ADDENDUM #2

City of Washington, Missouri
Busch Creek Greenway Project, TAP-6406(606)
February 17, 2022

**CITY OF WASHINGTON
BUSCH CREEK GREENWAY
TRAIL PLANS
TAP #6406(606) - Addendum 2**

SHEET: PLAN SHEET
1 OF 4

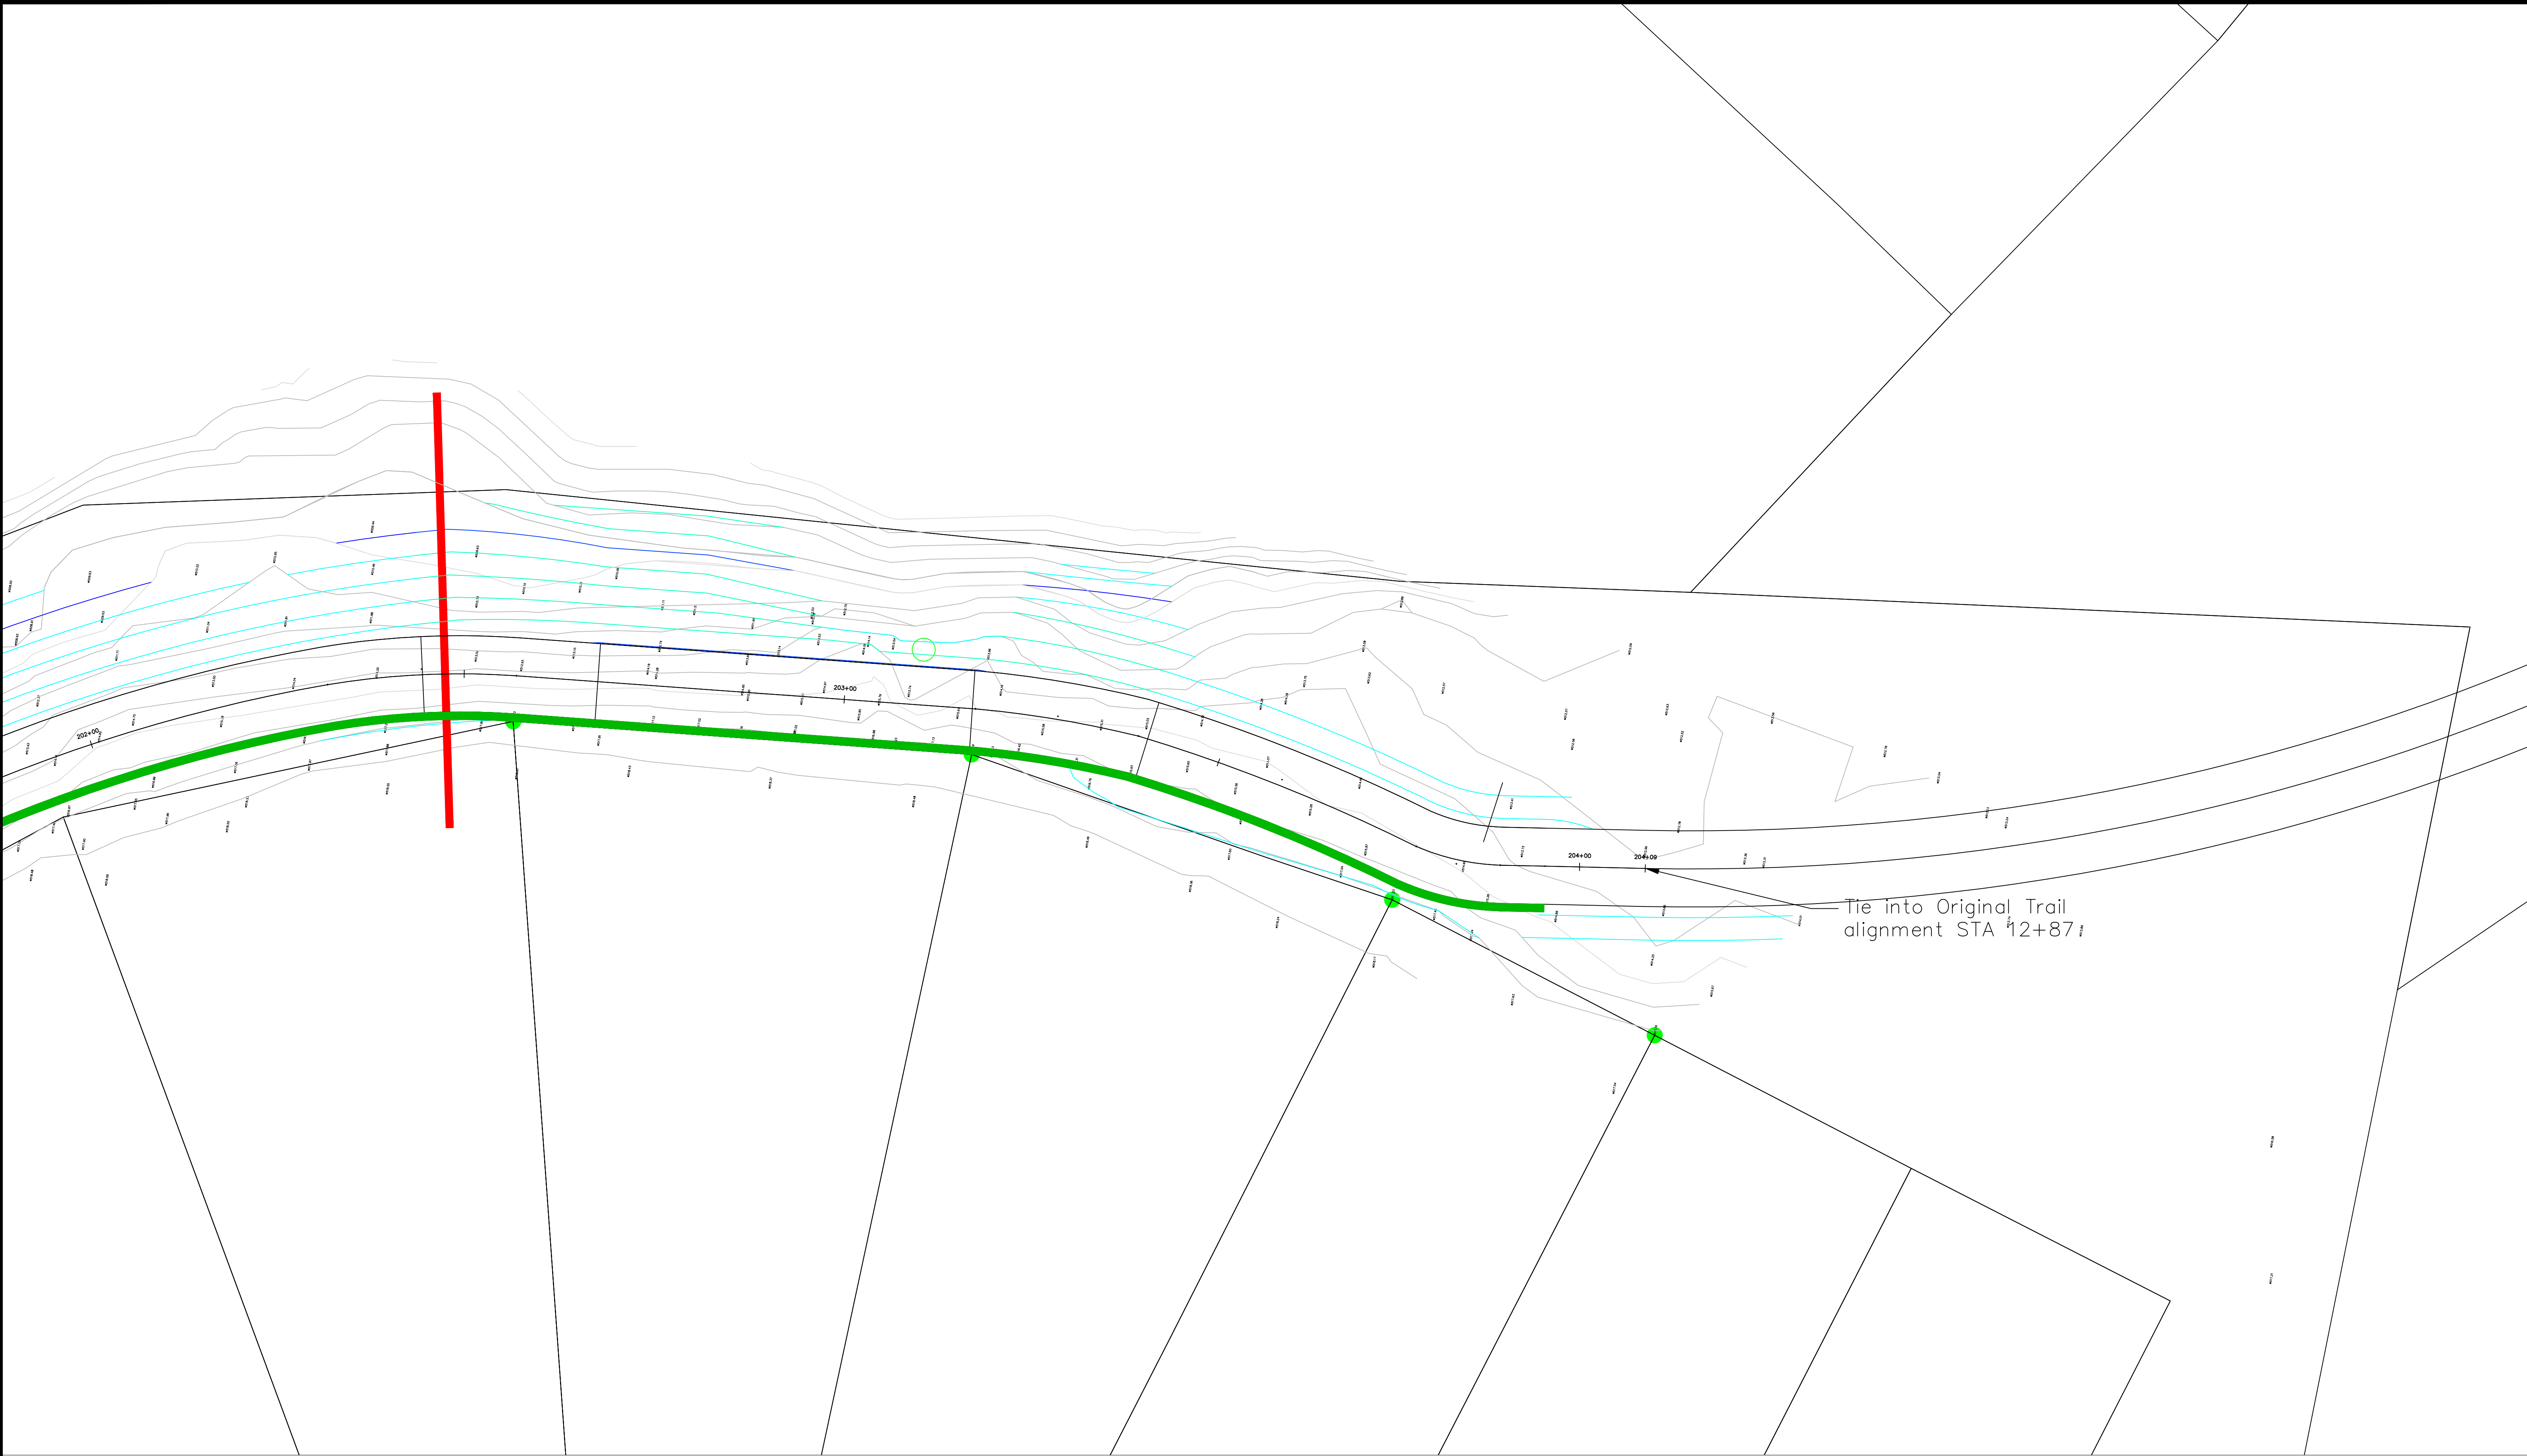
1. A retaining wall will be added to the project in the non-participating portion between shared use path Stations 8+80 thru 12+87. The retaining wall utilizes a separate stationing than the shared use path. Line Item #44 was added to the bid sheet under section "SITEWORK ITEMS - Non-Participating," plan sheet 2 was updated and four new retaining wall sheets 1-4 were created.
2. The updated bid sheet 2 of 2, plan sheet 2 and new retaining wall plan sheets 1-4 are attached. Replace Bid Sheet 2 of 2 on page 14-b in the current specifications with the attached Estimated Quantities Bid Sheet, replace Sheet 2 in the plans with the updated plan and include retaining wall sheets 1-4 in the plan set.
3. The bid due date was revised in Addendum #1:

Tie into Original Trail
alignment STA 8+80

Proposed
Retaining Wall
370 LF

SHEET: PLAN SHEET
2 OF 4

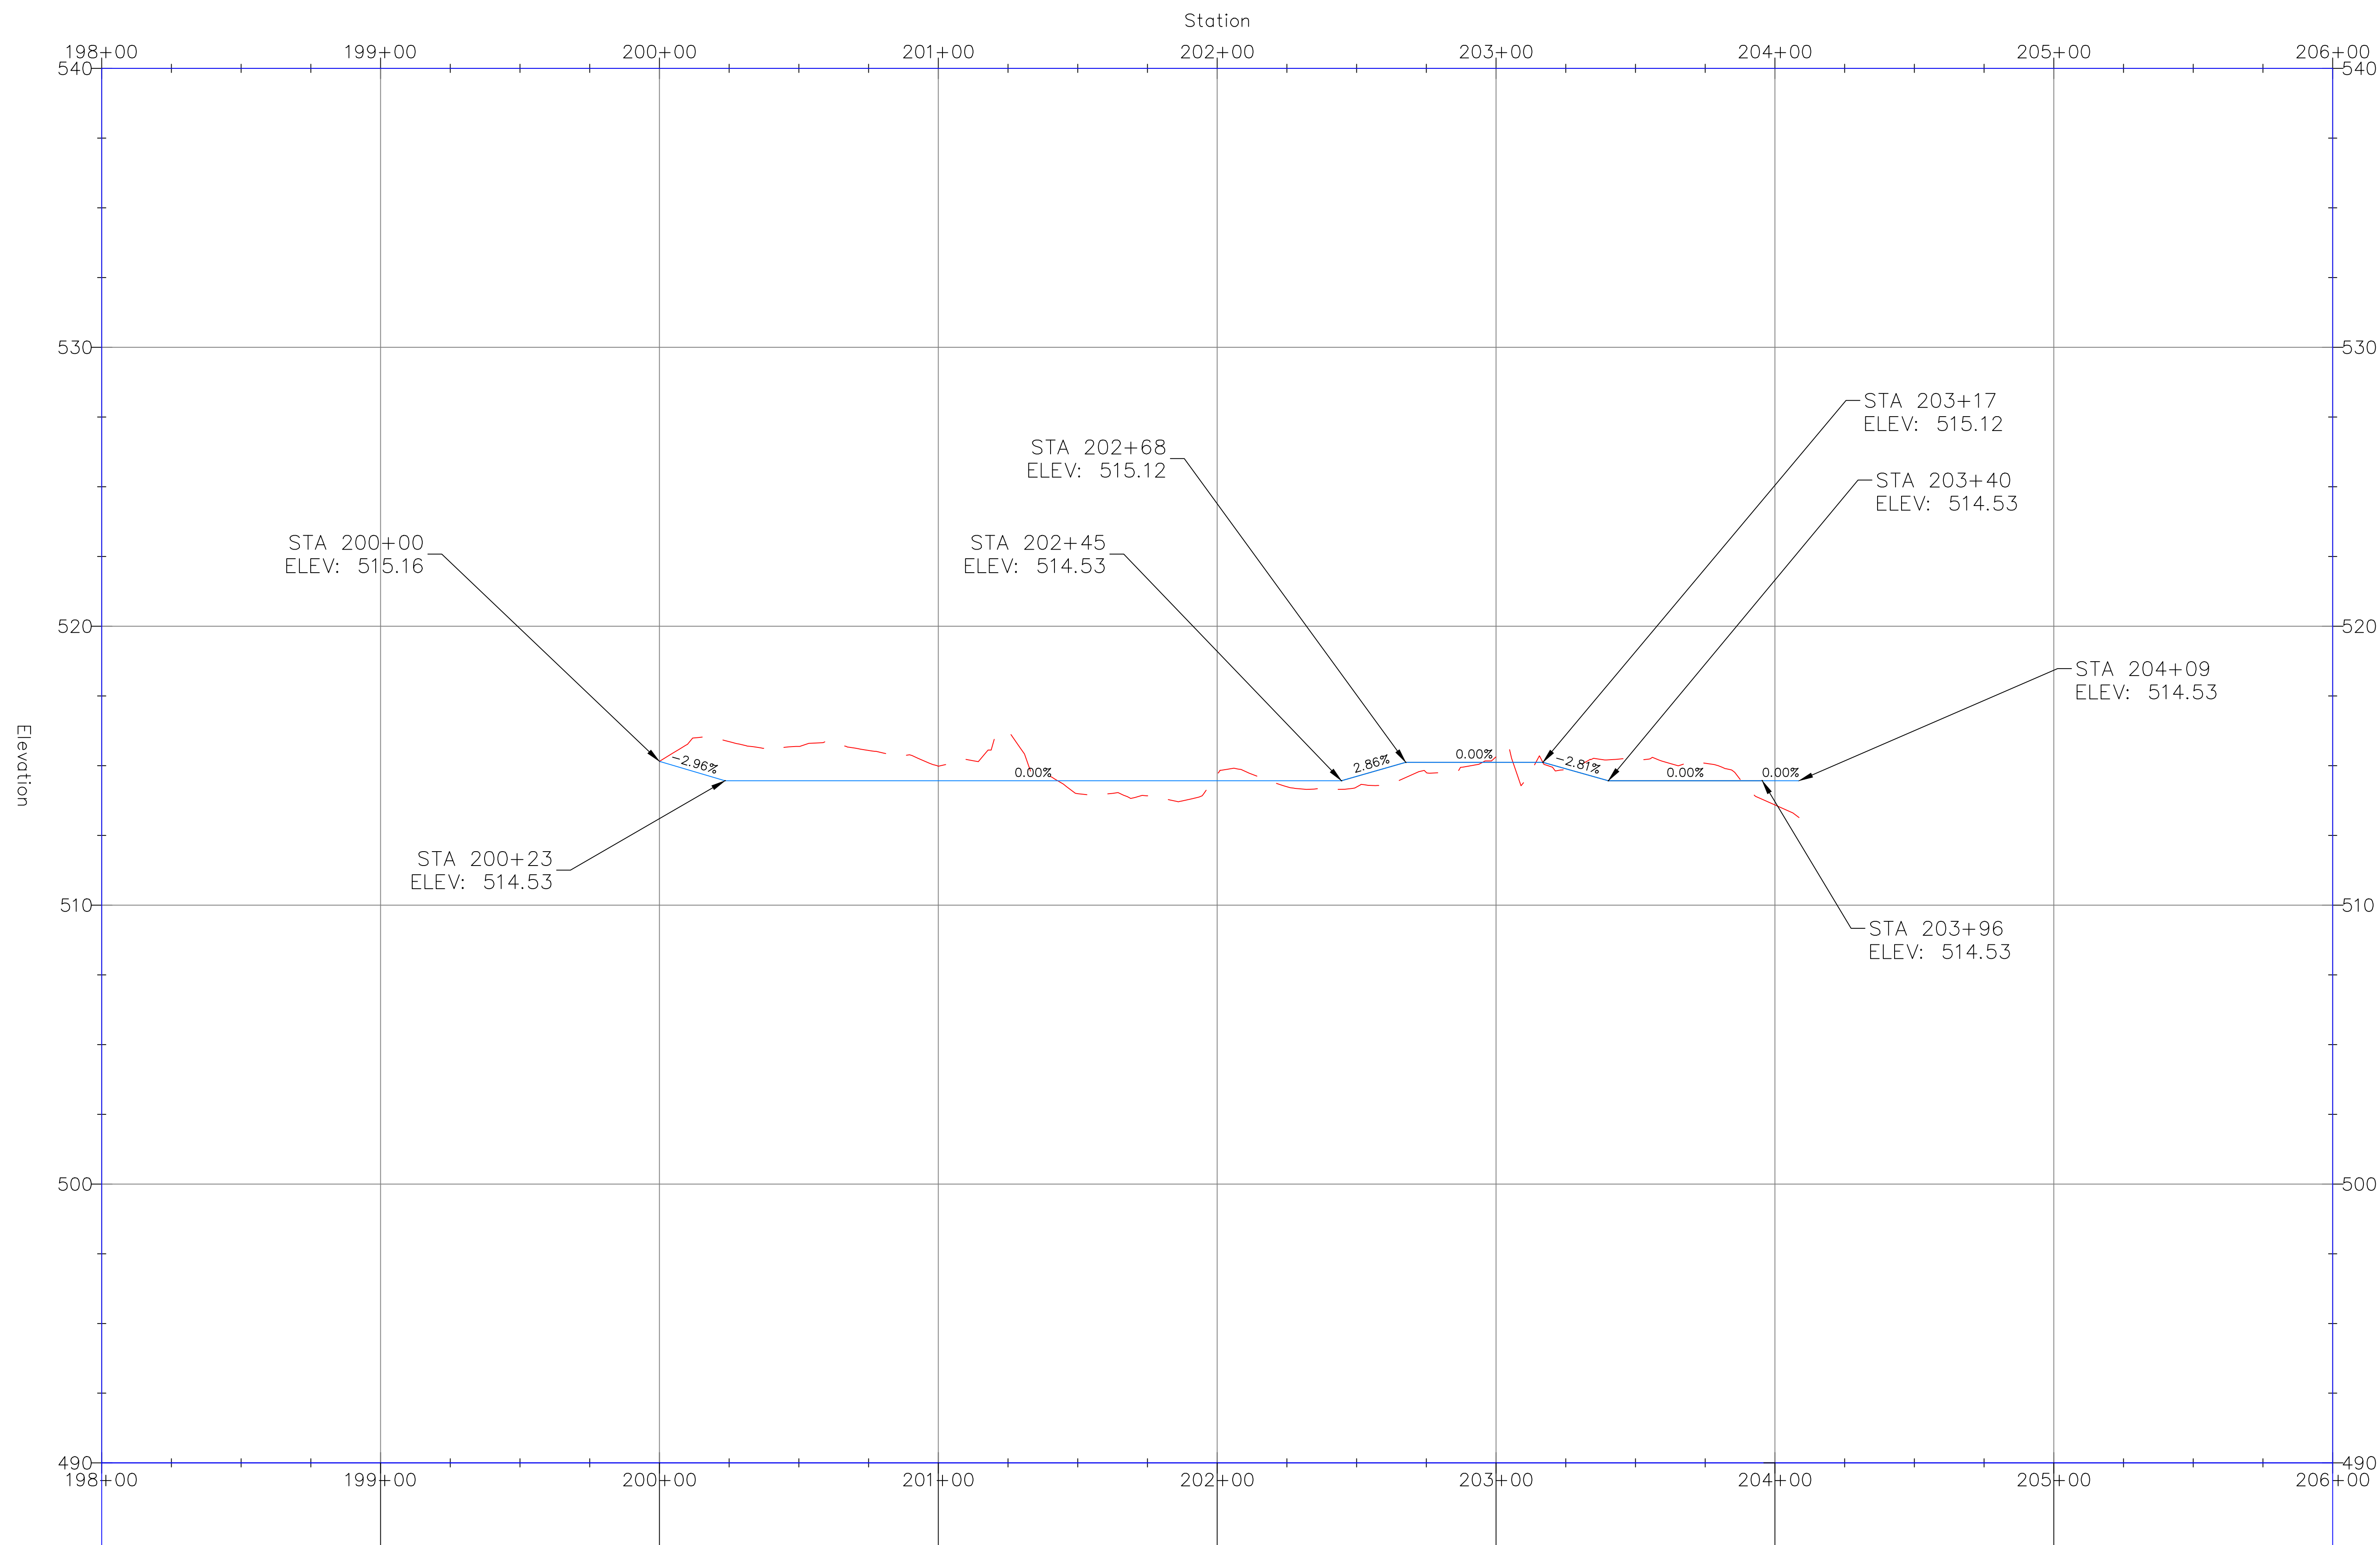
Proposed Trail Centerline Profile
